DELEGATE REPORT MINISTERIAL PLANNING REFERRAL

City of Melbourne file reference:	ID-2021-1
PS Amendment No.	C401MELB
Proponent:	Phillip Nominees Pty Ltd
Owner:	Phillip Nominees Pty Ltd
Architect:	Ingenhoven + Architectus + Seidler
Address:	1 Spring Street & 21-25 Flinders Lane, Melbourne
Proposal summary:	<p>Planning Scheme Amendment under Section 20(4) of the P&E Act 1987 to introduce a site-specific Incorporated Document and Specific Controls Overlay over the subject site, allowing the following development:</p> <ul style="list-style-type: none"> • Partial demolition of Milton House and Shell House, including reduction of the existing northern publicly accessible private plaza. • Construction of a new 32-storey (excluding 3 plant levels) commercial office building (new Tower 2) with mixed retail and publicly accessible foyer at Levels 2-3. • Refurbishment of Milton House. • New connections through to Shell House (aka Tower 1).
Cost of works:	\$203.5 million

The purpose of this report, is to provide an updated Council position on the plans which will be considered by the Advisory Committee, in relation to Amendment C401.

CoMPASS Aerial Photograph with approximate location of Tower 2 floorplate (Revision G (24-Feb-2022))

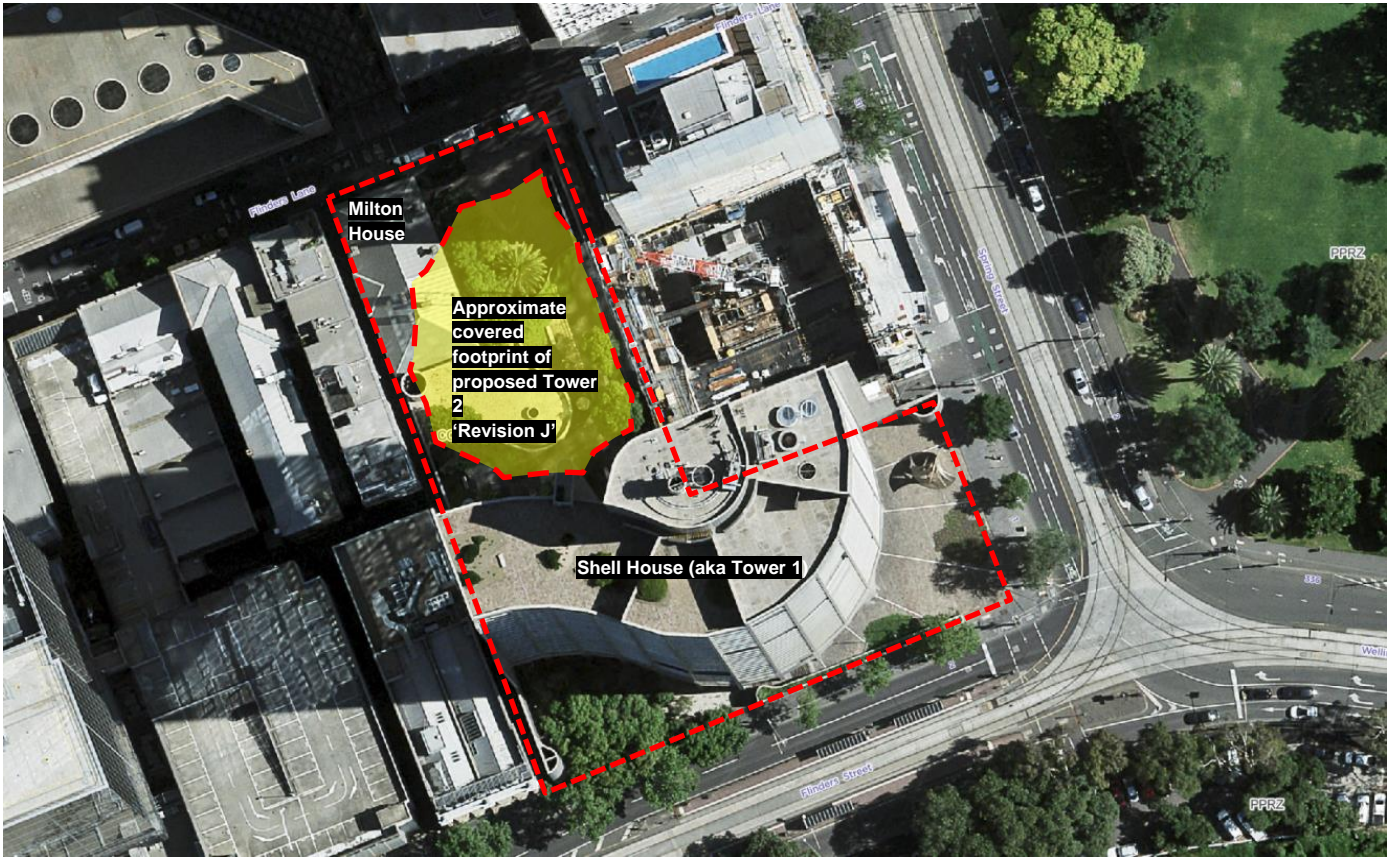
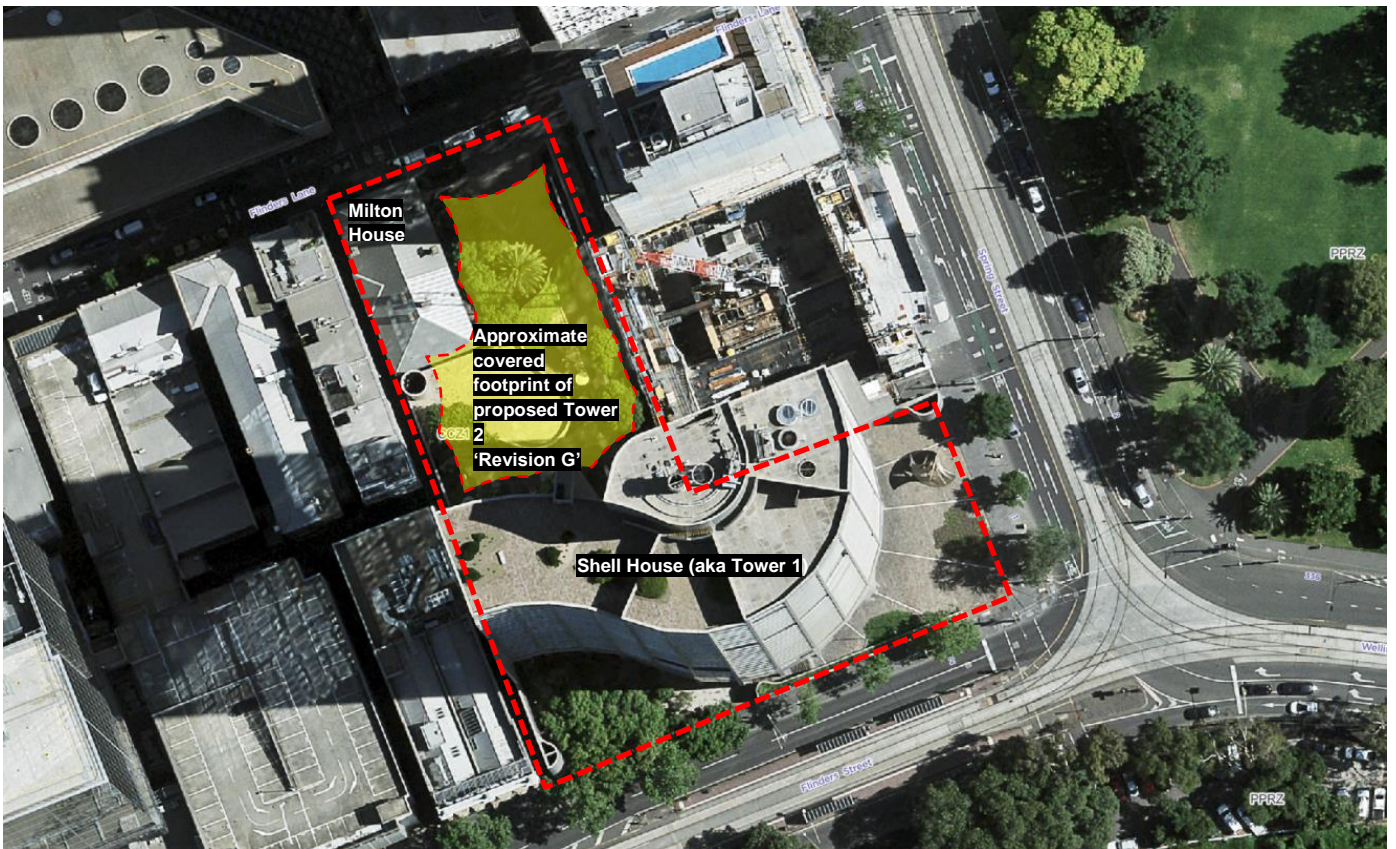
This design change reintroduces a significant cantilever of Tower 2's floorplate over Milton House.

Excerpt from Urban Context Report (Issue C) showing 'Revision J' presentation of Tower 2 soffit and interface with Milton House to Flinders Lane, including removal of landscaping (p.94 of 107)

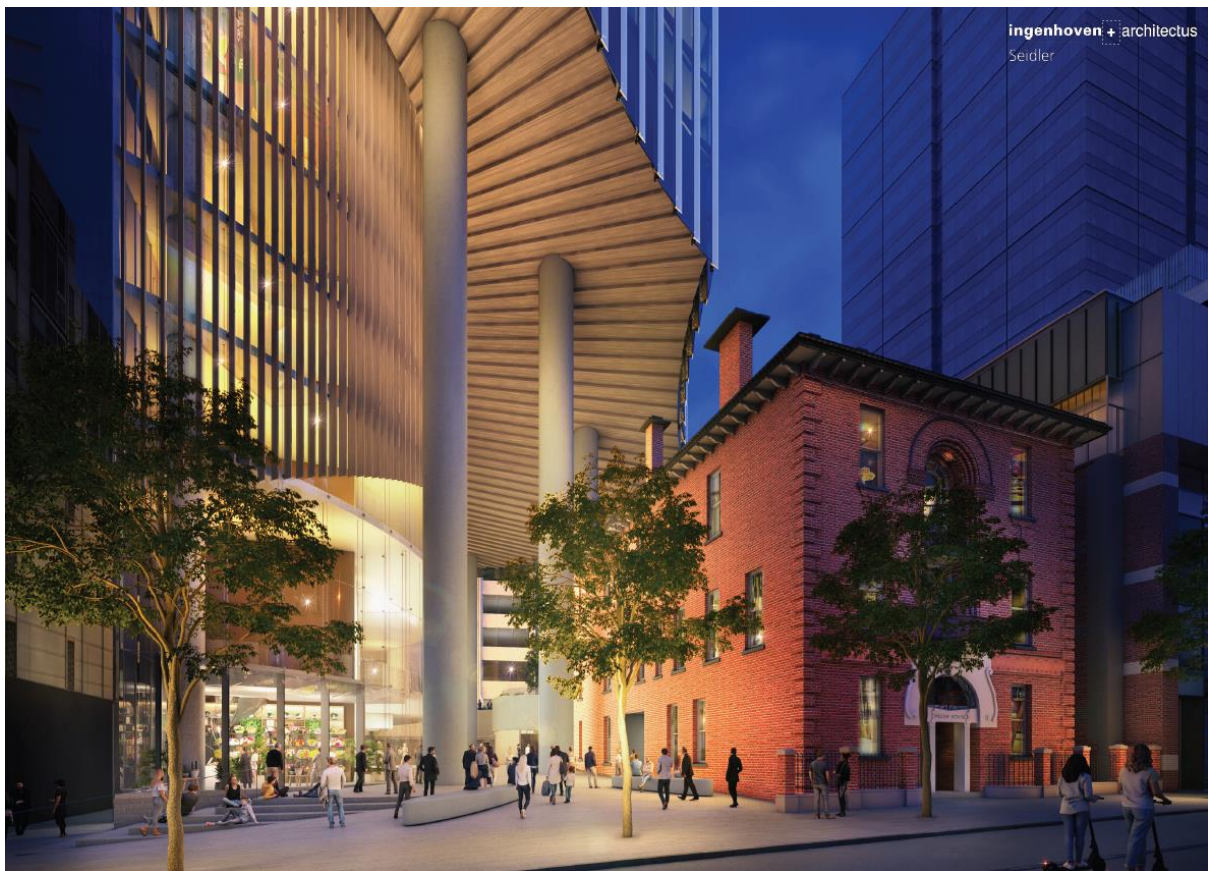
Retention of a greater volume of Shell House's podium and Level 3 terrace², has resulted in the existing through-block connection interface remaining largely unmodified, save for the introduction of one pedestrian entry at the rear of Milton House.

Modifications to this interface resolved through the assessment of Amendment C401 had sought to enhance this connection by providing a greater degree of activation / penetrations (including via landscaping and ornamentation), and a publicly accessible connection through to Spark Lane.

Excerpt from 'Level 3', Drawing No. DA1009, Revision G

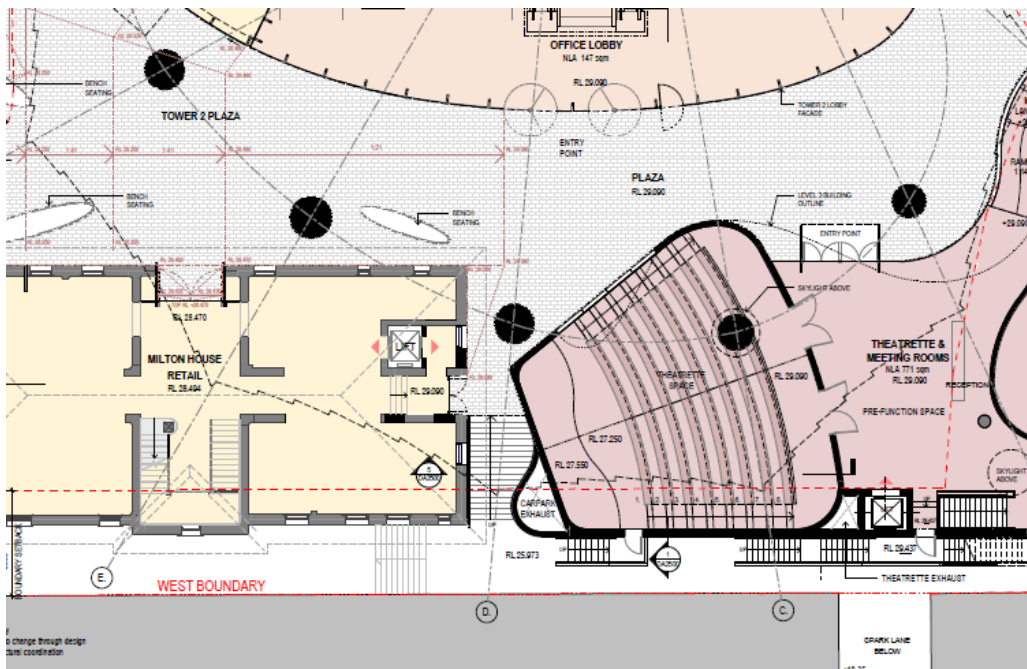
- Changes to the layout of the columns to proposed Tower 2, and the stair access to the publicly accessible interior foyer areas, impacting on the width, design quality and accessibility of the connection through to the western boundary pedestrian connection. This appears to severely compromise connectivity to the western boundary pedestrian connection achieved in the 'Revision G' development, and may create an unsafe environment for pedestrians.
- Relocating the external elevator to Spark Lane from the publicly accessible terraced café / landscaped area, to within the retained and reconfigured Theatrette & Meeting Rooms pre-function space, understood to be a private / restricted area. This appears to remove the connection to Spark Lane achieved in the 'Revision G' development.

Excerpt from 'West Elevation', Drawing No.DA2003, Revision G

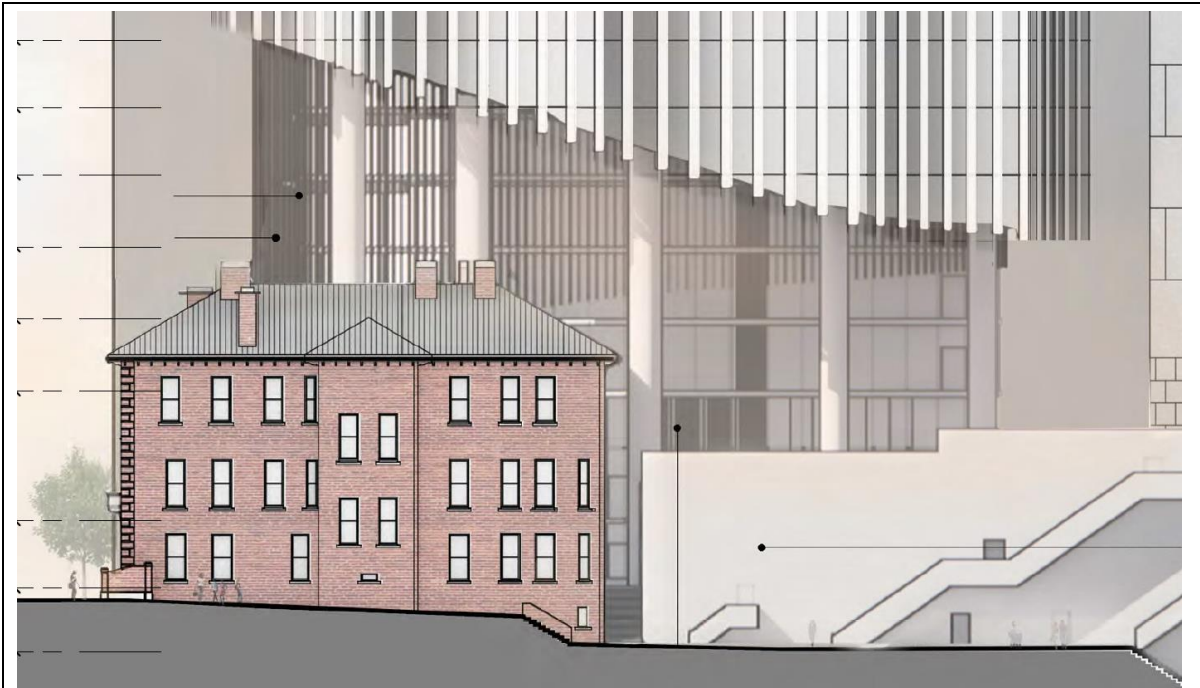
- Retaining a larger proportion of Shell House's podium has removed opportunities created by the original design to open up the interior publicly accessible areas to the western pedestrian connection and activate this space. The landscaped / ornamental treatment to the interface with the western pedestrian connection has been replaced with an inactive polished concrete treatment that will continue for the full height of the Shell House podium to the private terrace.

Excerpt from Level 2 (Flinders Lane), Drawing No.DA1008, Revision B

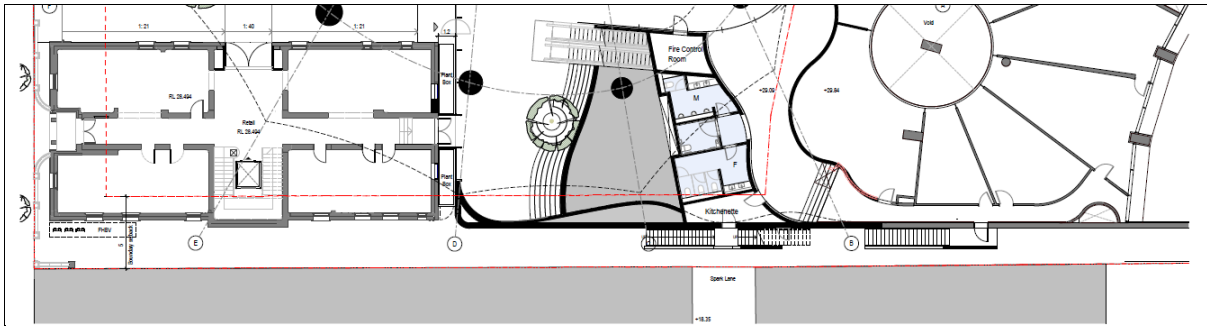
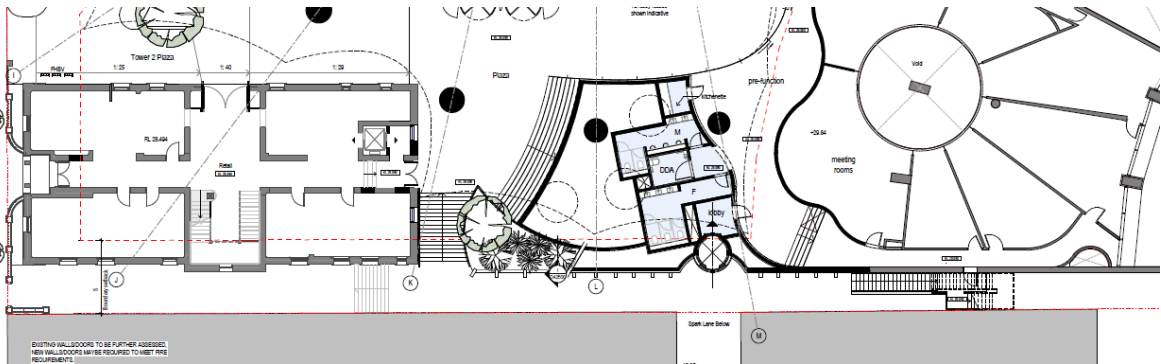
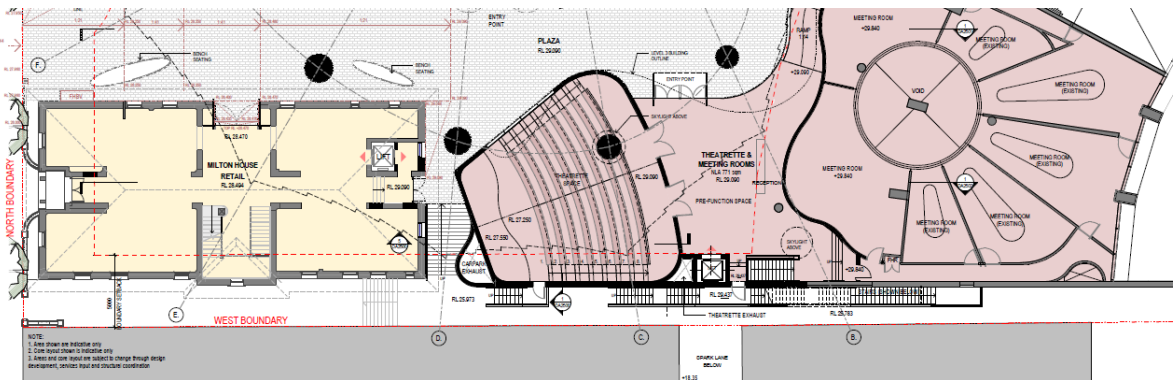
<p>Assessment: Does not comply with design outcome</p> <p>As set out in the consideration of the urban block structure and pedestrian connection design outcomes the 'Revision J' design compromises several initiatives that were considered to (cumulatively) contribute to the quality of the pedestrian environment around the site.</p> <p>These key design initiatives to improve the relationship between the development and the western pedestrian connection, and the compromised 'Revision J' design, have been demonstrated in the below excerpts from the architectural plans.</p>

Indicative annotated excerpt from 'Plaza Area Diagrams' (Issue B), dated 10 February 2022, with the revised layout of the 'Revision J' public accessible 'plaza' areas highlighted blue and uncovered areas outlined red.

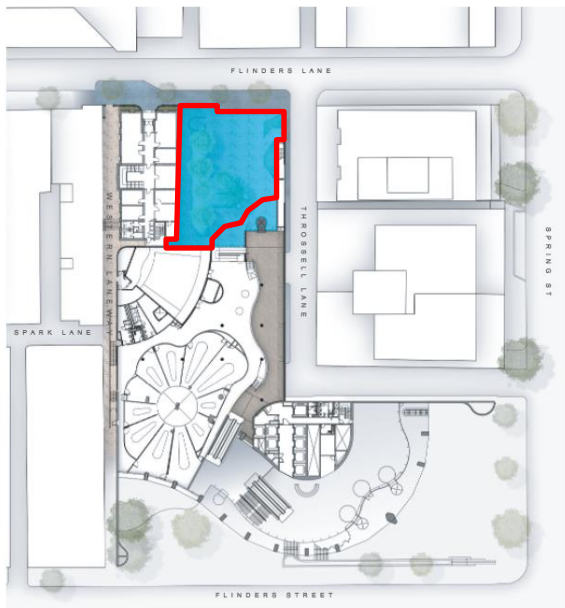
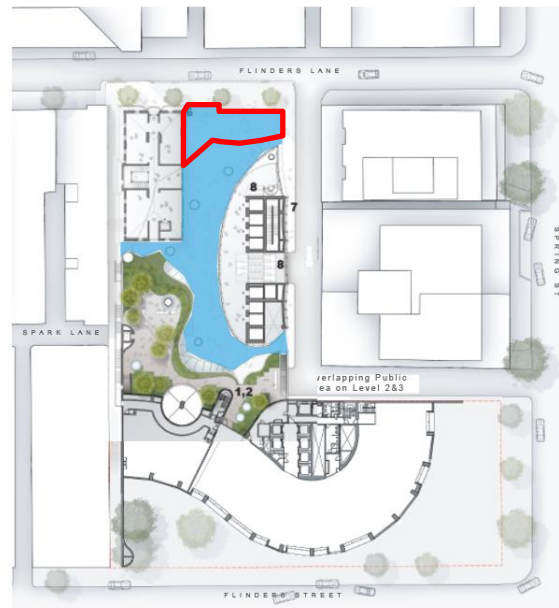
- Retention of a greater volume of Shell House's podium and private³ upper terrace (Level 3), including the reconfiguration of the 'Theatrette', which have significantly reduced the area of what the Proponent contends is a 'Plaza' within the development accessible to members of the public.
4. Deletion of the sky bridge connecting Tower 2 to Shell House at level 15 of the development.
 5. Reducing the height of Tower 2 from RL188.600, 38 storeys (including plant) to RL178.050⁴, 35 storeys (including plant).

³ The existing Level 3 terrace is for use by tenants of the building only (noted in Section 5.3 of the 'Revision J' Urban Context Report), and features access similar to that proposed in the 'Revision J' drawings. The 'Revision J' Architectural Drawings and Urban Context Report do not clearly show the revised Level 3 terrace design as being publicly accessible. In the event that this was the intention, it is noted that the revised design for the Level 3 terrace would not be suitable for public access as it is functionally separated from the ground level 'plaza' areas, and would be read as a de facto private area due to all access points being narrow and secluded (i.e. a narrow stair behind the podium to Tower 2 and internal elevator) from public view. The Level 3 terrace (existing and proposed) would not meet the design requirements for a Plaza.

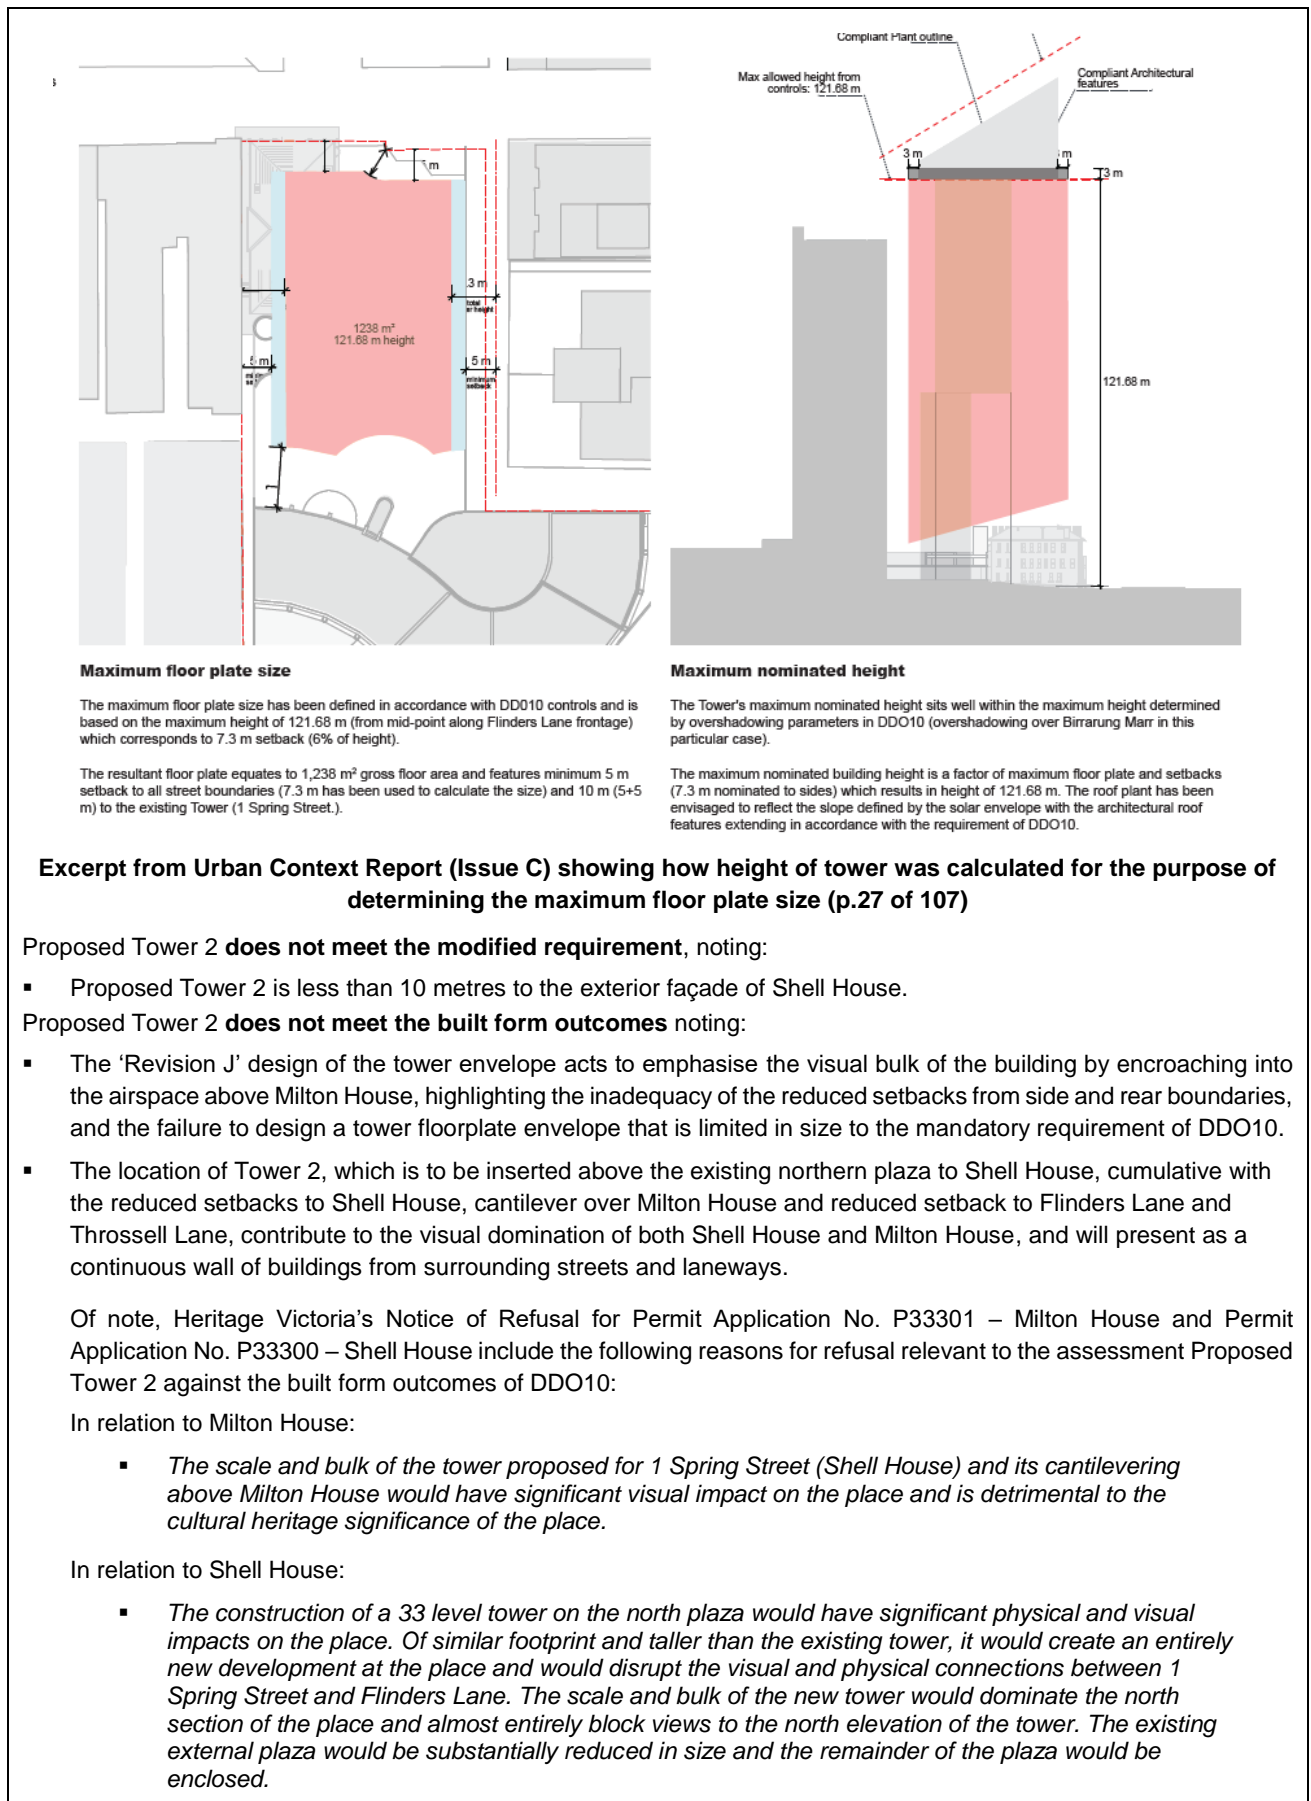
While the plant indicated inside the excess levels is setback 3.0 metres and can be considered compliant, the architectural features being the extended and sloped tower façade referred to in the below diagram exceed 3.0 metres in height. This is therefore non-compliant and it is appropriate to include this section of the tower when calculating the 'total building height'.

The 'total building height' of proposed Tower 2 has been calculated as 150.33 metres above a spot level of RL27.72 at the centre of the site's Flinders Lane frontage and 159.55 metres above a spot level of 18.5 at the centre of the site's Flinders Street frontage.

6% of 150.33 metres is **9.02 metres**.
